**BROWNS FERRY NUCLEAR PLANT (BFN) – UNIT 1 – RESPONSE TO
NRC ACCEPTANCE REVIEW LETTER AND REQUEST FOR ADDITIONAL
INFORMATION RELATED TO TECHNICAL SPECIFICATIONS (TS)
CHANGE NO. TS-431 – REQUEST FOR EXTENDED POWER UPRATE
OPERATION (TAC NO. MC3812)**

REPLY TO RESULTS OF ACCEPTANCE REVIEW AND REQUEST FOR ADDITIONAL INFORMATION FOR BFN UNIT 1 EXTENDED POWER UPRATE APPLICATION

Figure 1

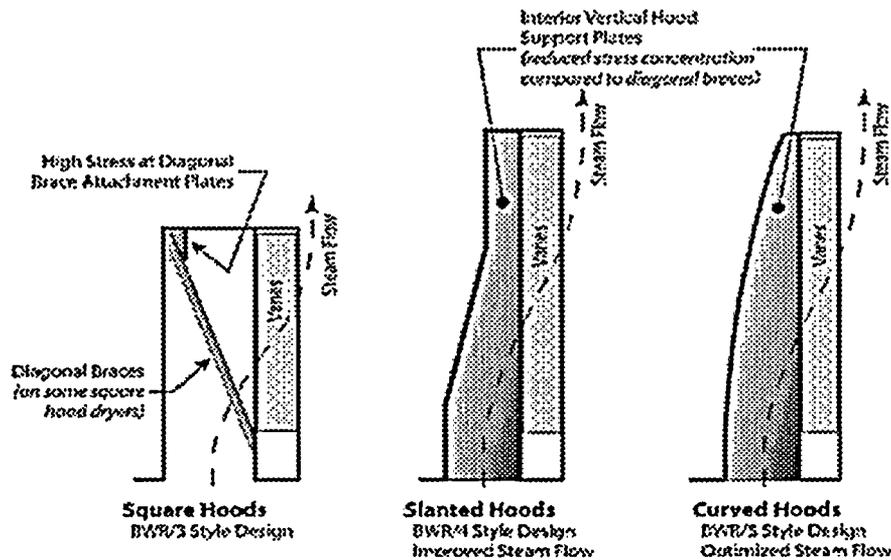
TVA's responses to the specific questions concerning the steam dryer analysis submitted in Enclosure 9 of the BFN Unit 1 EPU application is provided below. As stated in the responses below, TVA continues to collaborate with the industry to develop improved steam dryer load definitions and improve the steam dryer analytical model. However, there is additional basis to support a conclusion that the BFN Unit 1 steam dryers will maintain their structural integrity under EPU flow conditions. This information is presented below.

The steam dryer failures that occurred at the Quad Cities and Dresden power plants are in part related to higher steam flow velocities causing changes in Steam Dryer component loadings and consequent failure due to fatigue. Experience has also shown that the BWR3 "square hood" design of these plants appears to be more susceptible to the phenomena than the BWR4 "slanted hood" design installed in the BFN plants. Plants of BWR4 design currently operating at greater than 110% of OLTP, have not experienced the failures exhibited in the BWR3 fleet dryers, as confirmed through moisture content monitoring and visual inspections. It should be noted that Brunswick 1 is currently operating at 120% power with no apparent structural problems.

TVA has evaluated BFN current and forecast EPU steam flow velocities against the existing operating experience for BWRs that have implemented EPU. As shown in the following table, the evaluation shows that forecast main steam flow velocities (calculated at the reactor vessel steam nozzle) are substantially less than those measured at the Quad Cities and Dresden plants that have experienced steam dryer component failures.

The Main Steam line flow velocities, attributed to contributing to dryer failures at Quad Cities and Dresden Nuclear Plants, are significantly higher than the Main Steam line flow velocities at BFN. In fact, the predicted BFN flow velocities at EPU conditions are less than the Dresden and Quad Cities flow velocities at the original licensed power level. Data from the table above demonstrates that the Dresden and Quad Cities maximum steam line velocities of 207 fps and 226 fps are, respectively, 35.3% and 47.7% higher than the forecast EPU steam line velocity for BFN. The BFN EPU forecast steam line velocity of 153 fps is comparable with the current Brunswick 120% EPU steam line velocity of 149 fps and the Hatch Unit 2 115% EPU steam line velocity. Both the Hatch and Brunswick dryers are of the same dryer type as installed in BFN (slanted hood), and have had favorable dryer operating experience at these steam velocities.

The Dresden and Quad Cities plants are BWR3 designs which utilize a steam dryer design with square end hoods, making them more susceptible to adverse loading conditions than the BFN BWR4 design with slanted steam dryer end hoods. The BWR4 hood design incorporates a slanted hood face section and additional dryer bank stiffener plates, which provide significantly more restraint to the hood face over and above the BWR3 design
